DEVELOPMENT APPLICATION

PDPLANPMTD-2024/041806

PROPOSAL: Visitor Accommodation (Two Units)

LOCATION: 23 Sabre Place, Sandford

Site Plan

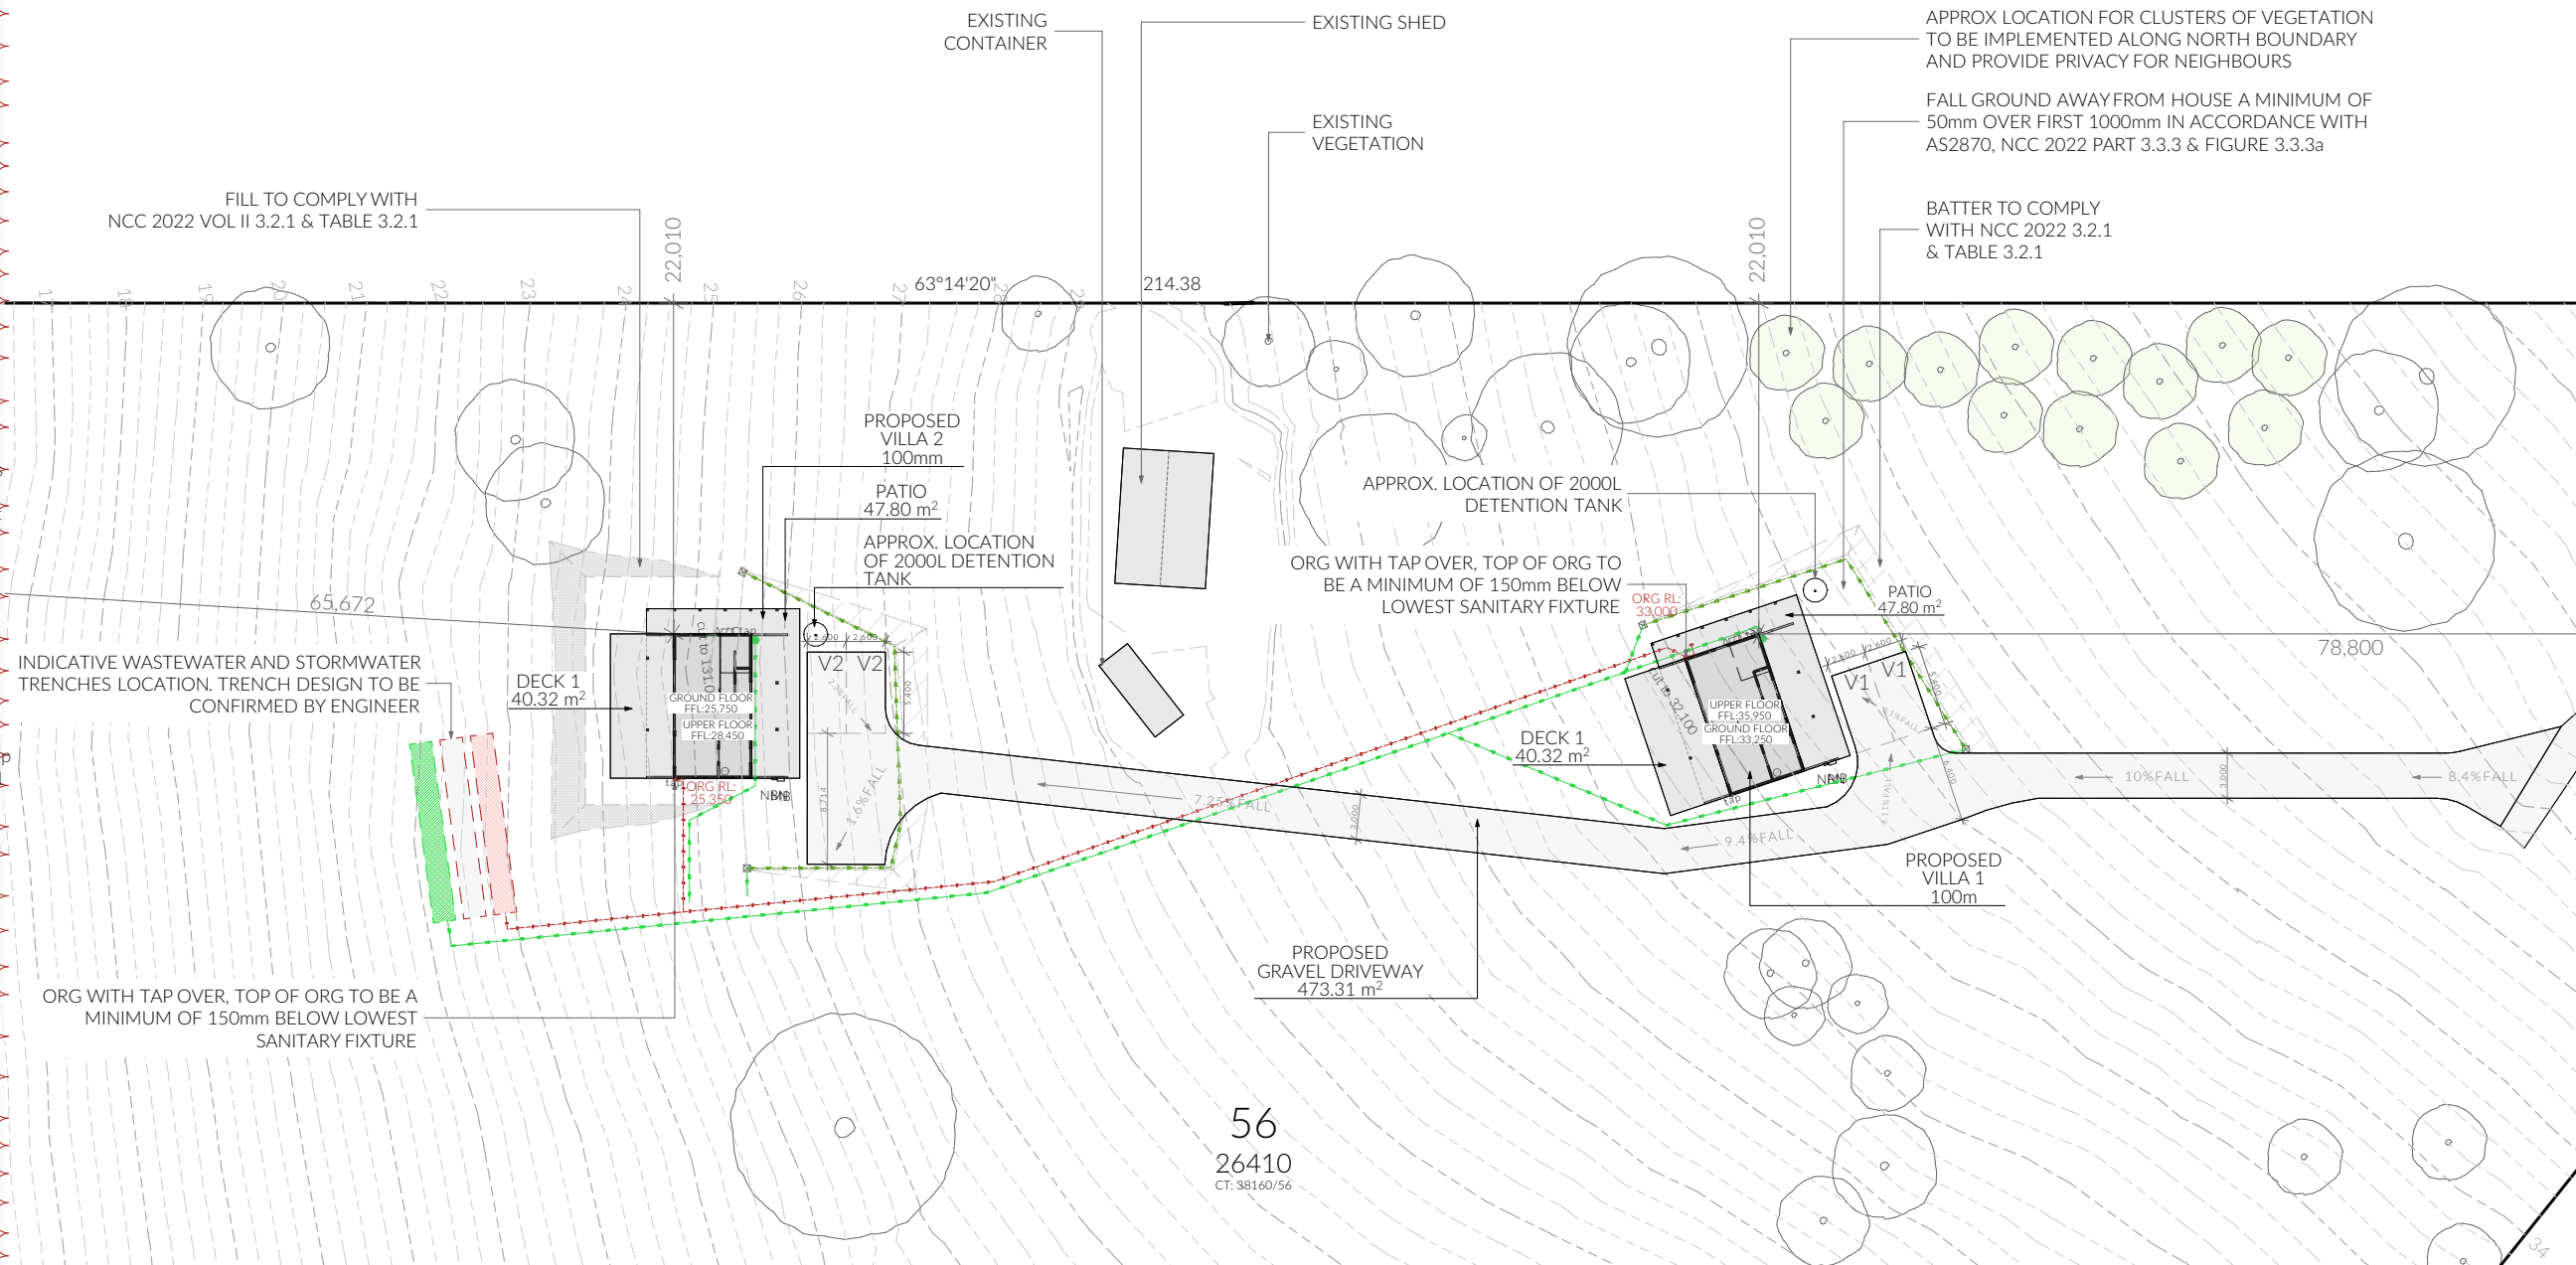
ITEM	COUNCIL REQUEST	DEVELOPMENT RESPONSE
1	<p>Cl.C2.6.1 Construction of parking areas (A1, A3)</p> <p>Please provide a written response addressing the performance criterion, P1, at the above Clause. For reference, this requires:</p> <p>All parking, access ways, manoeuvring and circulation spaces must be readily identifiable and constructed so that they are useable in all weather conditions, having regard to:</p> <ul style="list-style-type: none">(a) the nature of the use;(b) the topography of the land;(c) the drainage system available;(d) the likelihood of transporting sediment or debris from the site onto a road or public place;(e) the likelihood of generating dust; and(f) the nature of the proposed surfacing.	<p>P1</p> <p>The proposed development addresses performance criterion, P1, as per below:</p> <ul style="list-style-type: none">(a) The proposed gravel driveway is intended for the sole purpose of accommodating access for visitors to the proposed accommodations, and therefore the nature of the use is of irregular occurrence.(b) The proposed driveway follows the general topography of the block, descending towards the west boundary.(c) The proposed driveway is proposed with ditch drain, as detailed on Site Plan A.02, and disperses across the ground to not cause nuisance to dwellings and adjoining properties.(d) There is a 12m-long buffer between the front boundary and the cul-de-sac road, providing ample transition to minimize the likelihood of transporting debris onto the public road. Additionally, the proposal takes precedence over similar gravel driveways of adjoining properties, as seen on the Location Plan.(e) The proposed gravel driveway consists of 100mm Subbase A, layered with 100mm compacted FCR, thus the likelihood of generating dust is minimal.(f) As addressed in (e). Additionally please refer to Site Plan for a detail of the gravel driveway.

- 2 Cl.7.6.2 Clearance within a priority vegetation area (A1)
- Please note that we are also awaiting a response from the Department of Natural Resources regarding the natural values on the site, and any precautions or advice that may be necessary. In the meantime, please provide details of any intended vegetation clearance to be associated with the proposal.
- See amended Location Plan A.01. There is 1 vegetation proposed to be removed to accommodate the location of Villa 2, which is also out of the priority vegetation area.
